Naval Facilities Engineering Command Needs to Improve Controls Over Task Order Administration

SUBJECT: Naval Facilities Engineering Command Needs to Improve Controls Over
Task Order Administration (Report No. DODIG-2015-141)

Of the 11 Guam MACC task orders executed and administered in Guam, we nonstatistically selected task order N62742-10-D-1308-0001 for review. The task order was awarded on May 10, 2010, for approximately \$23.4 million, and modified 22 times. The modifications added approximately \$6.7 million to the task order, for a total value of \$30.1 million. The task order was for MILCON Projects P-465 and P-528.

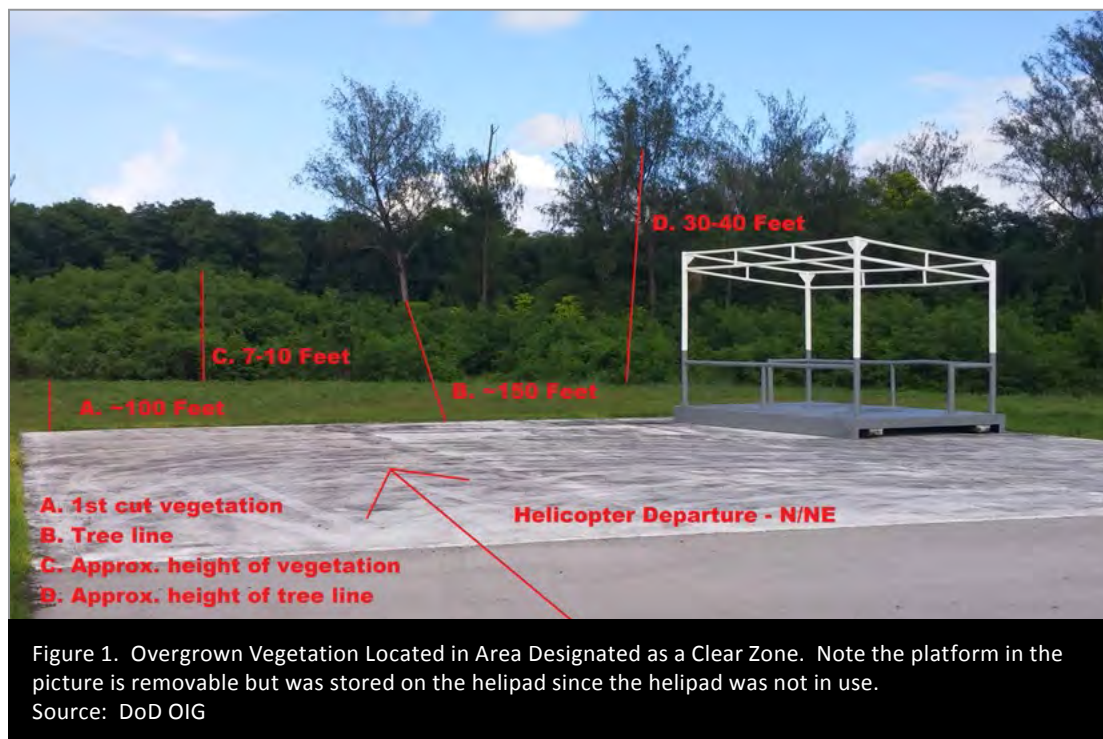
After the modification work was complete, a February 2014 site survey conducted by Helicopter Sea Combat Squadron 25 (helicopter squadron) determined the helipad was not the safest or most efficient option to launch and recover torpedoes and did not recommend using the helipad until additional improvements were made. As of April 2015, DoD expended approximately \$572,000 for the helipads and the surrounding area that would require at least \$321,000 of additional work to be functional. Specifically, NAVFAC personnel drafted a work request in September 2014 to address the Helicopter Squadron's logistical requirements. As written, the request does not address the coating and marking deficiencies identified in this report. As of the report date, a contract had not been issued.

Contract administration personnel did not reference or meet UFC size requirements when developing the specifications for the helipad modification. According to the UFC, the Navy-required helipad size is 100 feet by 100 feet (10,000 square feet). The modification required the contractor to build a "50 feet by 50 feet (2,500 square feet) epoxy-coated concrete helipad." In addition to not meeting the UFC requirements, the modification specifications did not meet mission requirements as the smaller helipad cannot accommodate the helicopter and all of the equipment required to conduct efficient operations.

Contract administration personnel did not ensure the modification established the appropriate “clear zone” required by the UFC. According to the UFC, a clear zone of 425 feet (north/south) by 150 feet (east/west), is required from the edge of the helipad. The clear zone is required to be “free of obstructions” with a maximum grade (slope) of 5 percent. However, the modification specifications did not adequately define these clear-zone requirements and at approximately 100 feet from the north edge of the helipad, the vegetation was approximately 7 to 10 feet tall. Further, there was a second line of trees approximately 30 to 40 feet tall located approximately 150 feet from the helipad (Figure 1). Consequently, the helicopter squadron could not safely launch the helicopter and torpedo equipment.

Contract administration personnel did not include surface coating specifications from the original task order, or perimeter and identification markings required by Naval Air Systems Command, in the helipad modification. Task order specifications² state that floor finishes, including the helipad, shall be “non-slip.” However, the surface of the helipad was slippery and traction was limited. The helipad surface also lacked the identification and perimeter markings for landing and takeoff during daytime operations as required by Naval Air Systems Command.

The Commander, NAVFAC, Marianas, agreed, stating that they evaluated the requirements for the helipad and developed a preliminary project package that will meet the applicable standards and guidance. In addition, NAVFAC Marianas evaluated the requirements for the hazardous waste storage and executed contract actions to resolve the collection trench size, appropriate floor slope, and door gaps. Finally, the storage area walls that are constructed of louvers will be evaluated and appropriate actions will be taken to meet applicable standards and guidance. NAVFAC Marianas plans to complete these projects by June 30, 2016.

Figure 2. Visible Gap Under Hazardous Waste Storage Room Door. Exterior View Shows Close Proximity to Surrounding Environment.
Source: DoD OIG

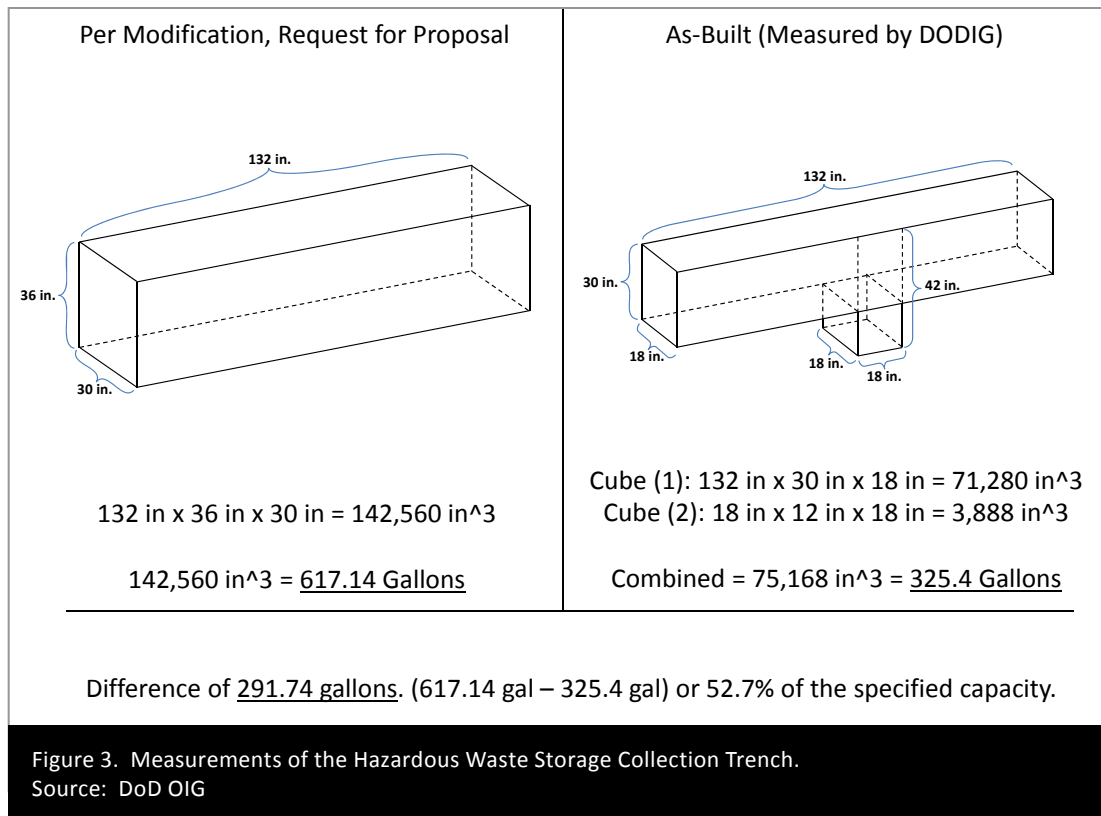
NAVFAC Marianas contract administration personnel did not ensure the hazardous waste storage area was properly enclosed. The CFR requires hazardous waste storage areas be enclosed to prevent exposure and to contain managed wastes. However, a visible gap existed under the hazardous waste storage room exit door that could allow hazardous liquid material to flow into the surrounding environment.

Additionally, storage area walls were constructed entirely of louvers⁵ (Figure 2) which would not be sufficient to contain a spill. Also, rain-water was in the collection trench, which likely entered the room through the gap or louvers. The trench was covered with a metal grate as shown in Figure 2 (left).

NAVFAC Marianas contract administration personnel also did not ensure the floor slope in the hazardous waste storage area was adequate to ensure liquids drained into the collection trench as required by the CFR. While an exact floor slope was not defined in the guidance, the floor was not visibly sloped toward the trench. Further, the facility's site manager stated he had observed water pooling on the areas around the trench rather than draining into it as required.

Finally, NAVFAC Marianas contract administration personnel did not ensure the collection trench built in the hazardous waste storage area could contain sufficient volume to meet customer needs. In the modification request for proposal, NAVFAC Marianas officials stated the collection trench should hold approximately 617 gallons, which would be sufficient to contain a spill from the customer's 550-gallon hazardous material container. However, the collection trench capacity was approximately 325 gallons (See Figure 3).
